# PLANNING REPORT

# HELFRICH RESIDENCE

## 23-027V

# 23-037V Helfrich Residence - Garage Door Height

North Elevation

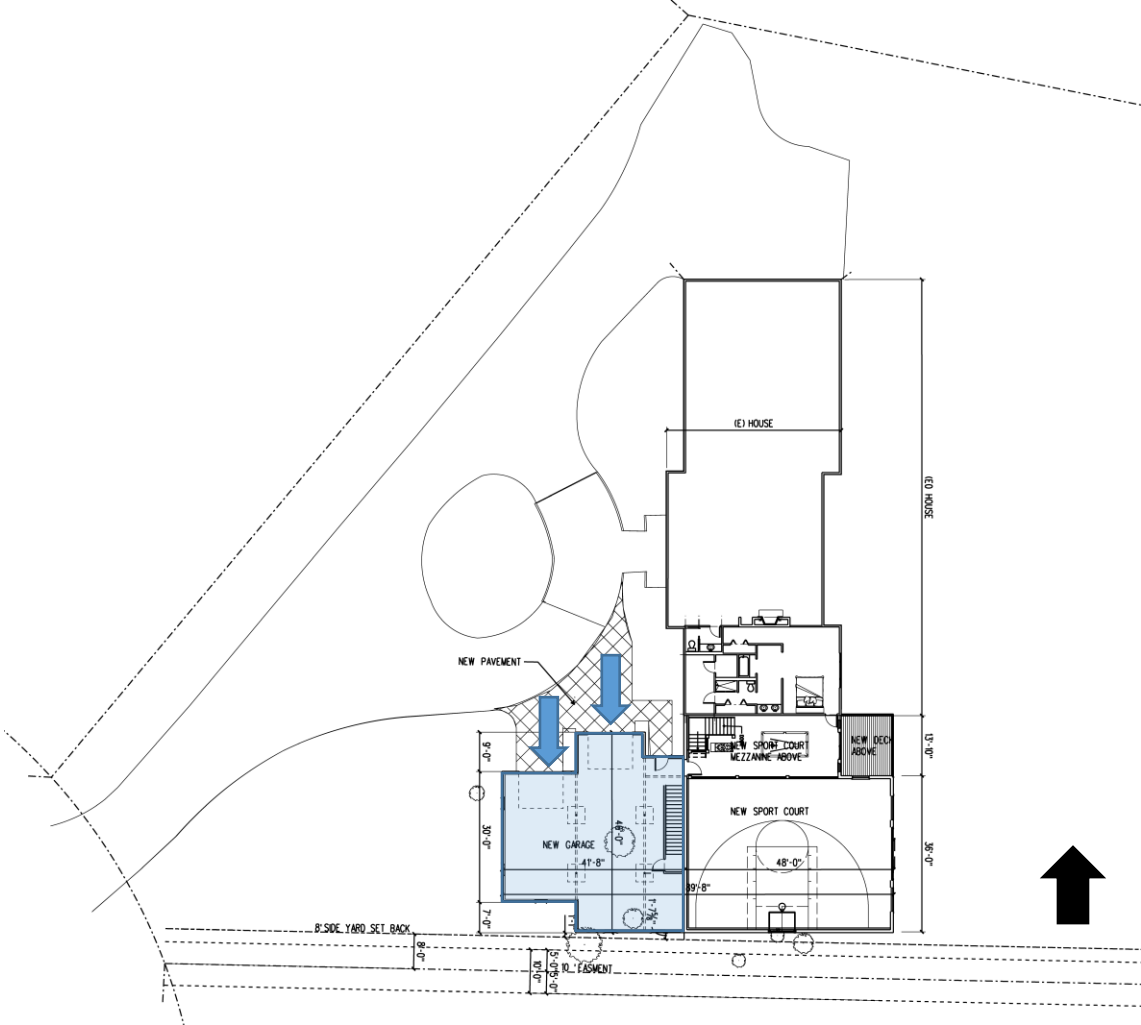
The applicant is requesting a Variance that would allow a future side-loaded attached garage addition to have two garage doors that exceed the maximum garage door height requirement of 9 feet. One door is proposed to be 12 feet and the other door will be 10 feet. Per the applicant, the 12-foot tall garage door is to accommodate a 10.5-foot tall handicap accessible vehicle for a family member. The 10-foot tall garage door is proposed to reduce the height differential between the 2 new garage doors, not to accommodate the handicap vehicle. The proposed garage is located on the southwest corner of the existing home, and the garage doors will be facing north towards the north property line. The proposed garage doors will not be visible from Locust Hill Lane, or from adjacent properties due to existing vegetation and grade changes.

Criteria	Review
1. That special conditions and circumstances exist which are peculiar to the land or structure involved and which are not applicable to other lands or structures in the same zoning district whereby the literal enforcement of the requirements of this chapter would involve practical difficulties.	<b>Criteria Met:</b> The site is larger than a typical suburban lot, irregularly shaped, and is in a wooded area. Additionally, the home is angled towards the west property line, allowing for the proposed side-loaded garage doors to be screened from the street. Based on the geometry of the lot and the form of the house, the garage doors will not be disproportionate or out of character with the existing house.

2. That the variance is not necessitated because of any action or inaction of the applicant.	<b>Criteria Met:</b> The variance request for the 12-foot door is necessitated due to medical needs of the applicant, as the garage is proposed to accommodate a handicap accessible vehicle for a family member. The proposed 10-foot-door does not meet this standard as it is the result of the applicant's desire to reduce the height differential between the two doors.

3. Granting the variance will not cause a substantial adverse effect to the property or improvements in the vicinity or will not materially impair the intent and purposes of the requirement being varied.	<b>Criteria Met:</b> The proposed addition meets all setback requirements for the lot. Due to the location of the garage doors, visibility from the right-of-way will be minimal, if visible at all. The Variance will not adversely affect the surrounding properties.

4. The practical difficulty could not be eliminated by some other method, even if the solution is less convenient or most costly to achieve.	<b>Criteria Not Met:</b> The vehicle could be stored off-site or on the driveway, providing an alternative method available to the applicant.

**Planning Recommendation:** Approval of the Non-Use (Area) Variance to Zoning Code Section 153.190(E)(1)(f)(3)(d) to allow a garage door to exceed the 9-foot maximum height requirement with 1 condition:

- 1) The applicant bring the 10-foot tall garage door into compliance with the height requirements.
